The Sewerage & Water Board OF NEW ORLEANS

Addendum No. 2

Your reference is directed to the Invitation to Bid for: **2024-SWB-22 Maintenance and Repair of Algiers Water Tower** for the Sewerage and Water Board of New Orleans, which proposals are due on **May 29, 2024**, at **11:00 a.m.** CST.

CHICAGO BRIDGE & IRON COMPANY
GENERAL PLAN
 200000 GAL SPHER ELEV TK
 SEWERAGE & WATER BOARD CITY OF
 NEW ORLEANS, LOUISIANA

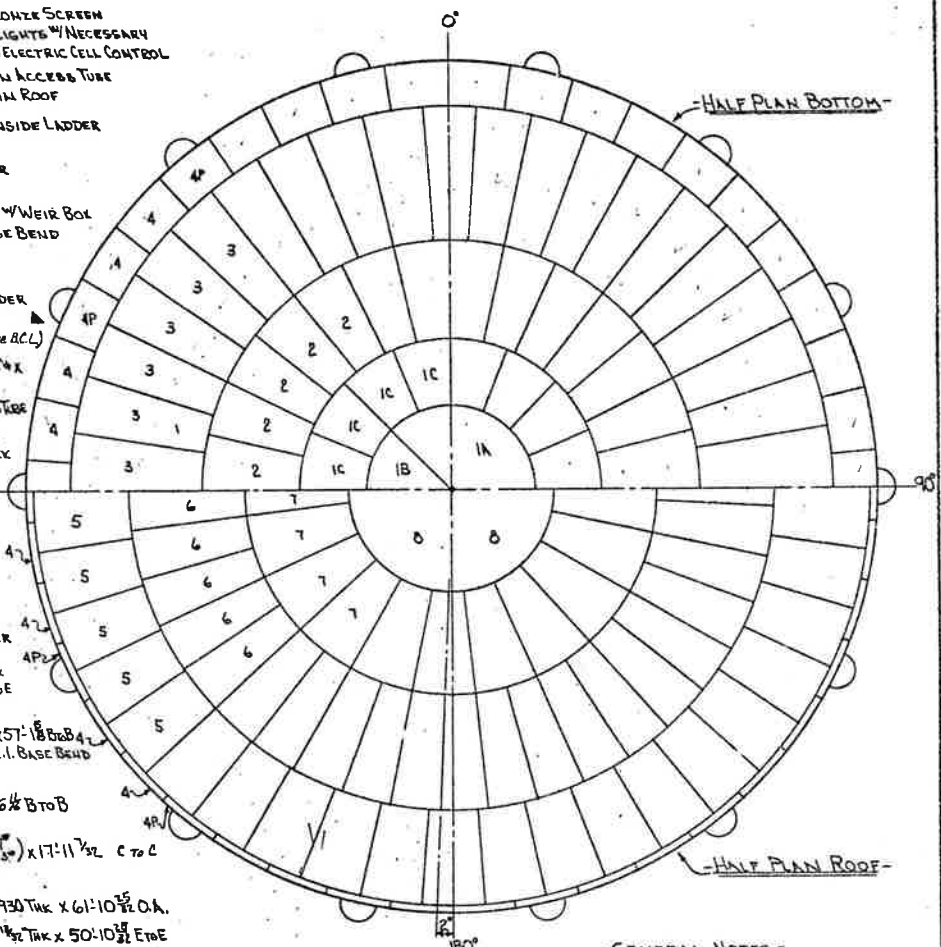
7. Are there rigging plugs installed?

10. How many ladders are in the tower to be replaced and are there drawings reflecting that?

11. In regard to the ladders inside the tank, in the plans on drawing no. 11878-W-13 under the coating schedule and legend C-7, it is calling for the ladders to be hot dip galvanized as a prime coat. Question: Could the ladders be stelllll and primed with the coating specified in C-1 in the same section?

Per Engineering, There are no known rigging plugs, but there are painter's clips as shown on the attached Original Tank Drawing with this addendum (Page 7). Per drawing 11386 1 W-13 supplied with specifications states painter's clips are spaced about 8' 0" on centers near the apex on the roof, around tank just below the water line.

Per Engineering, There are two ladders involved with the scope, the main manway and the main hatch. They are shown in the original tank drawing attached to this addendum. The New ladder is from the manhole to the tank floor.

Per Engineering, The ladders do not require galvanizing as a prime coat. The drawings attached to spec are for reference only. Current industry practice is for the ladder to match the paint and primer spec.

First Coat: Tnemec Series 91 H2O Hydro-Zinc, thickness 2.5-3.5 dry mils.

Intermediate coat: Series 21 Epoxoline beige 5.0-7.0 dry mils.

Finish coat: Series 21 Epoxoline 5.0-7.0 dry mils.
